Subject: Bishop's Creek Community Development Corporation
4759 North 32nd Street
Milwaukee, Wisconsin
FID No. 341055770
BRRTS No. 02-41-306192
BRRTS No. 02-41-553373
Giles Project No. 1E-0912014

Giles has prepared this revised correspondence in response to address the questions presented in the Wisconsin Department of Natural Resources (WDNR) correspondence dated November 11, 2010, which provided notification of receipt of the WDNR Dredging Permit Application 3500-53J for the above referenced property ("Site"). The following correspondence provides additional information, responses/clarifications, and supporting documentation to assist with the WDNRs review of the permit application. Giles responses to your inquiries are included below.

FIGURE 1
SITE PLAN
 BISHOP'S CREEK COMMUNITY DEVELOPMENT CORPORATION
 4759 N. 32nd STREET
 MILWAUKEE, WISCONSIN

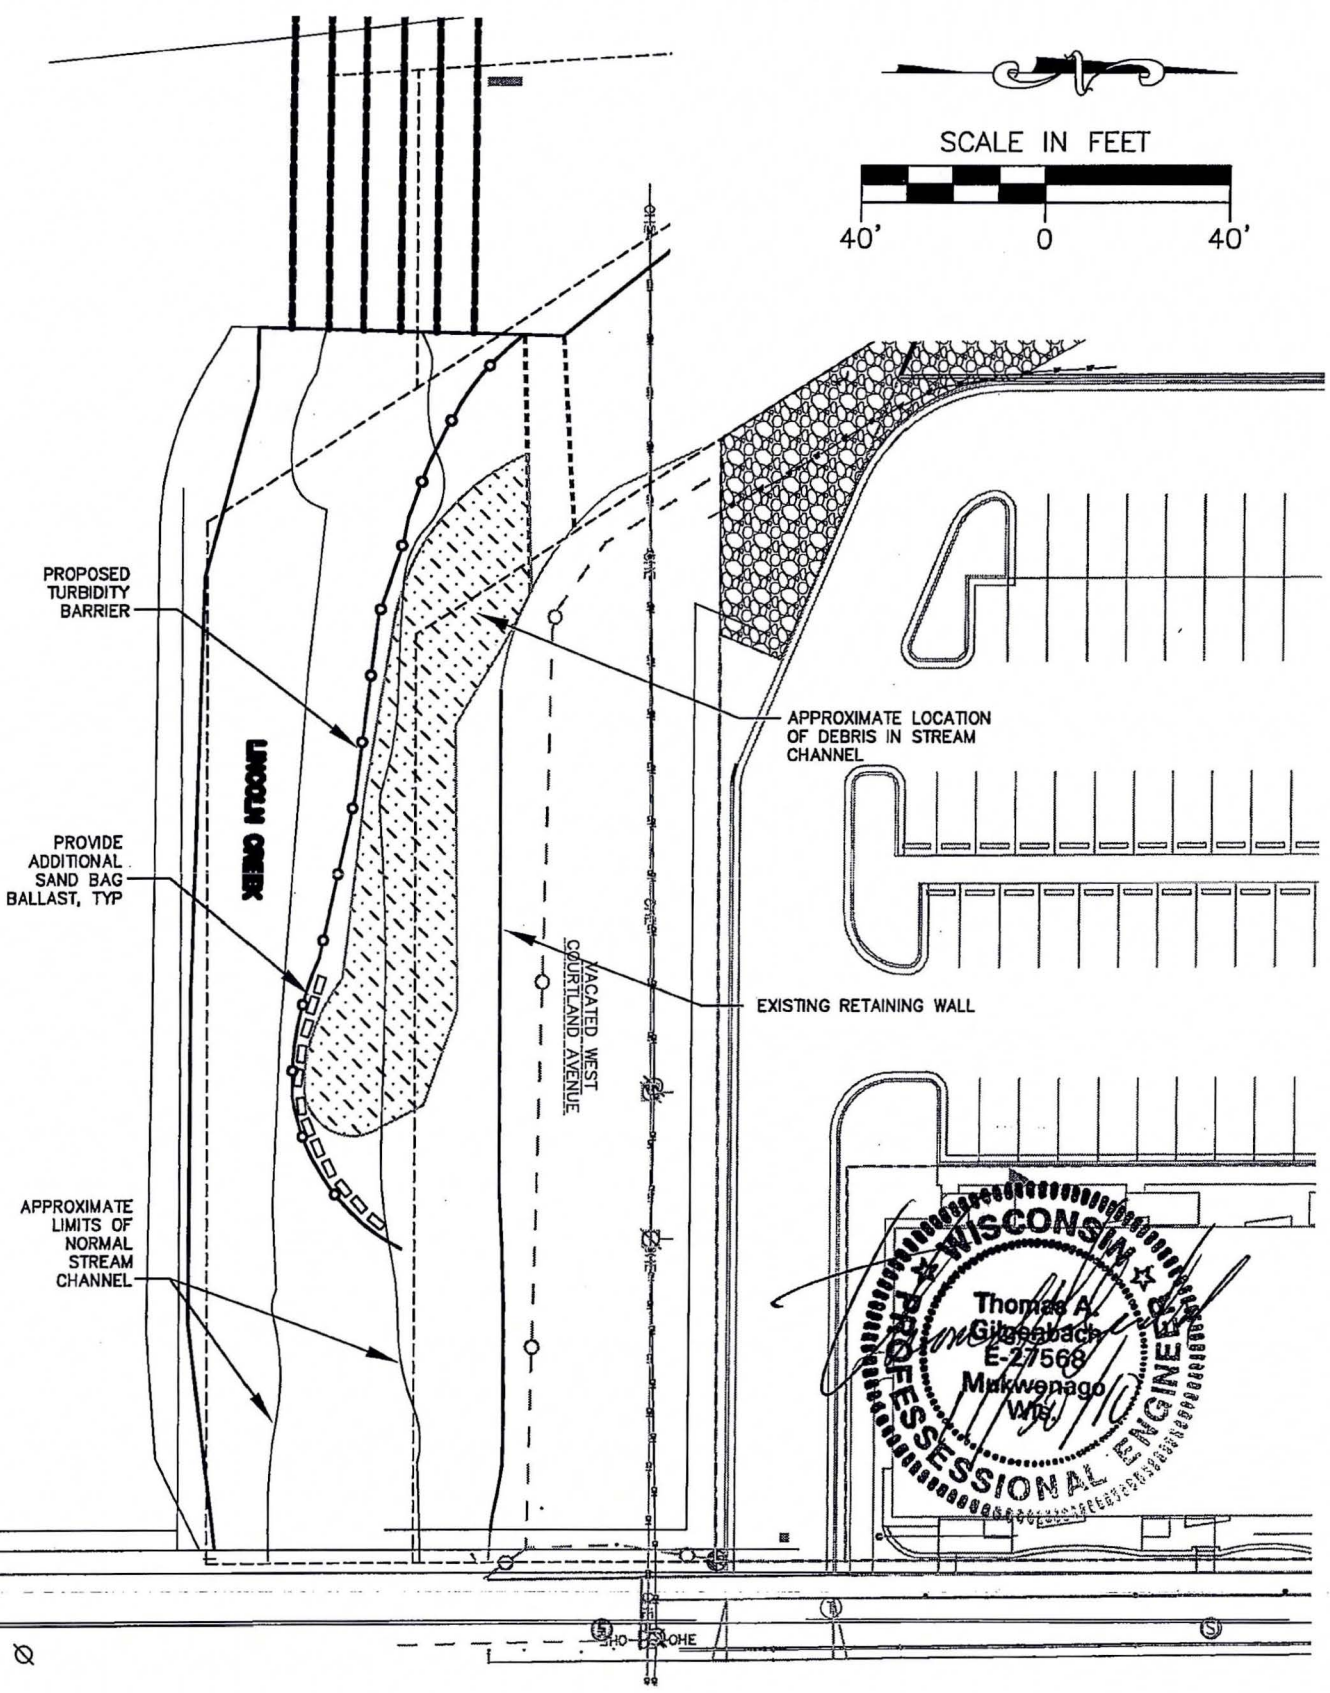
- 1). ...**"Provide a plan sheet that shows the location of the temporary access road, and removal limits within Lincoln Creek"...**

- 3). ...**Provide an erosion control plan that meets or exceeds the State of Wisconsin's Construction Erosion and Sediment Control Technical Standards for the removal of the accumulated debris in Lincoln Creek. These standards are found at"..."Show the location of all the practices to be installed and provide details for each practice"...**

Please see the attached Figure 1 for the referenced temporary access road and removal limits within Lincoln Creek.

The contractor will implement temporary silt fencing (WDNR Conservation Practice Standard 1056) around the perimeter of the debris staging area as shown in Figure 1. In addition, a filter fabric pad will be placed within the staging area.

SHEET NUMBER
C-1A
JSD PROJECT NUMBER
09 3500
SCALE
1"=40'

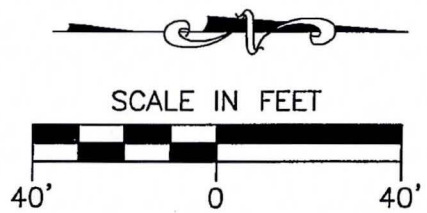
- 2). ...**"Provide a detailed construction sequence for the removal of the accumulated debris in Lincoln Creek. This sequence must reflect the proper installation of sediment control practices in relation to the removal of the accumulated debris in Lincoln Creek"...**

- *Establish temporary sediment dredging erosion control measures within Lincoln Creek. The sediment dredging erosion control measures will consist of the placement of a 3-foot high turbidity barrier parallel to the direction of flow in between the debris and sediment and the creek base flow, in accordance with the WDNR Conservation Standard 1069 (See Attached Engineering Drawings C-1A and C-2A).*

The contractor will implement temporary sediment dredging erosion control measures consisting of the placement of a turbidity barrier parallel to the direction of flow in between the debris and sediment and the creek base flow, in accordance with the WDNR Conservation Practice Standard 1069 (See Attached Engineering Drawings C-1A and C-2A).
